PRELIMINARY/ FINAL LAND DEVELOPMENT PLAN FOR

REPLER INVESTMENTS LP.

CENTRAL PA SWEEPERS

Re: 380 Hershey Road (Repler Investments L.P.)
Preliminary/Final Land Development Plan
Township Permit No. 23-05-FLDP
LCEC Project No: 25-135

CONSTRUCTION, SIGNING & PAVEMENT MARKING PLAN
 Application #335174
 for
REPLER INVESTMENTS, LP.
 situated in
 Mount Joy Township
 Lancaster County, Pennsylvania
 Date: September 06, 2024 Drawing No.: LC-13

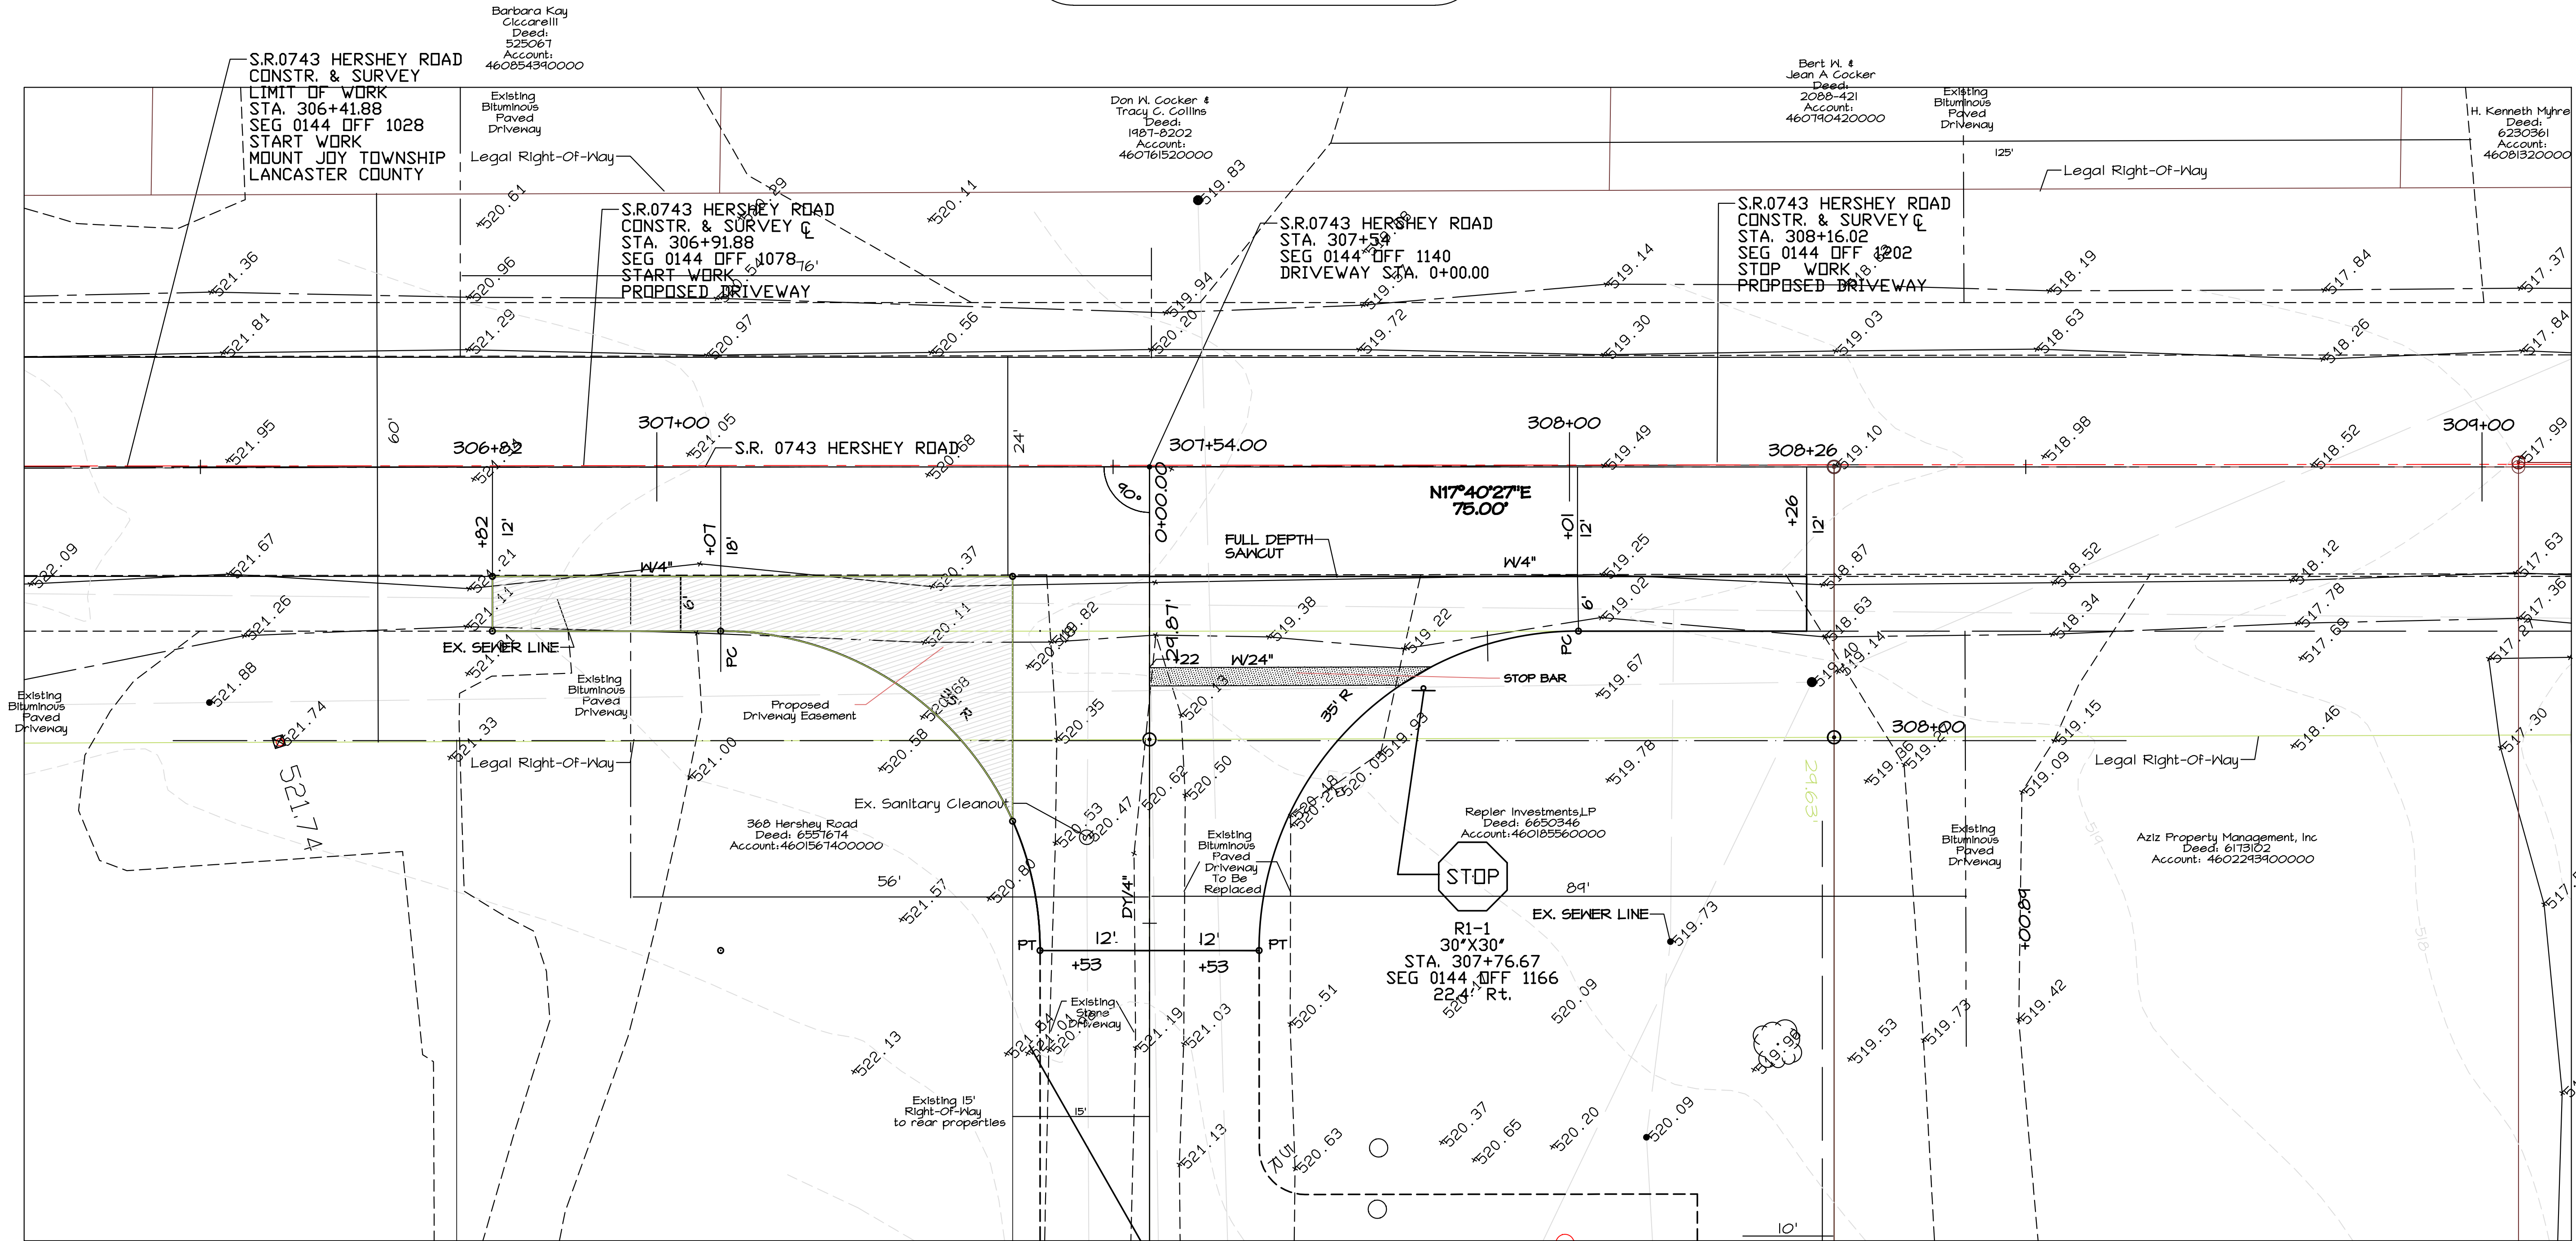
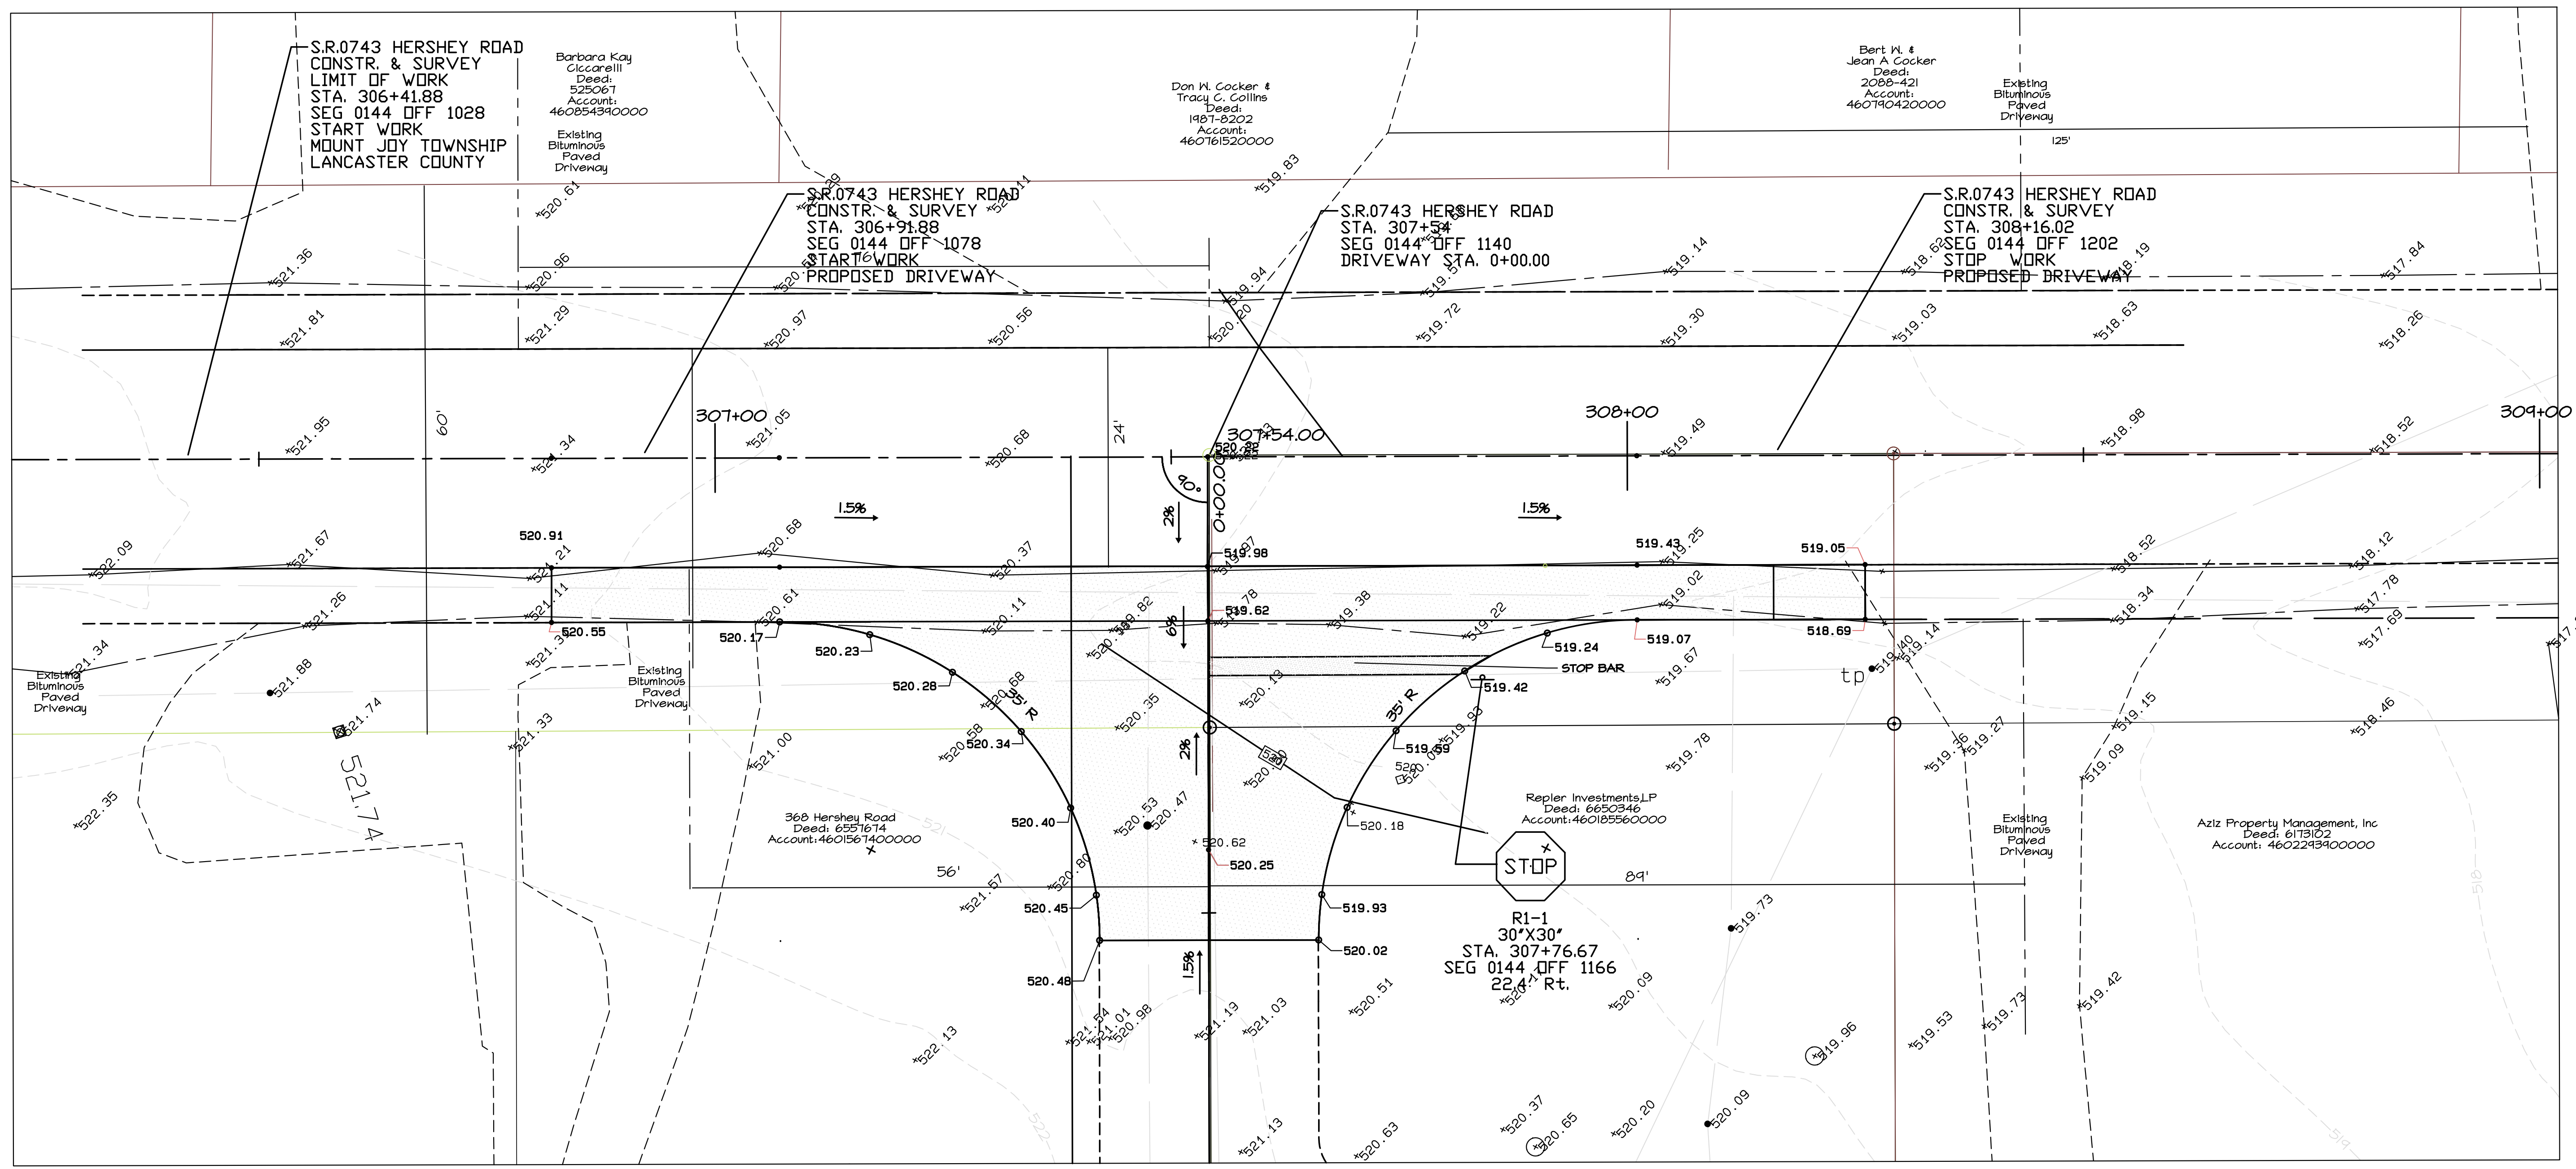
18. It appears the extents of the asphalt paving improvements shown on the Highway Occupancy Permit Plans are inconsistent with the extents of the asphalt paving improvements shown in the Driveway Typical Section In PennDOT R.O.W. construction detail (119-52.J(3)(e)).
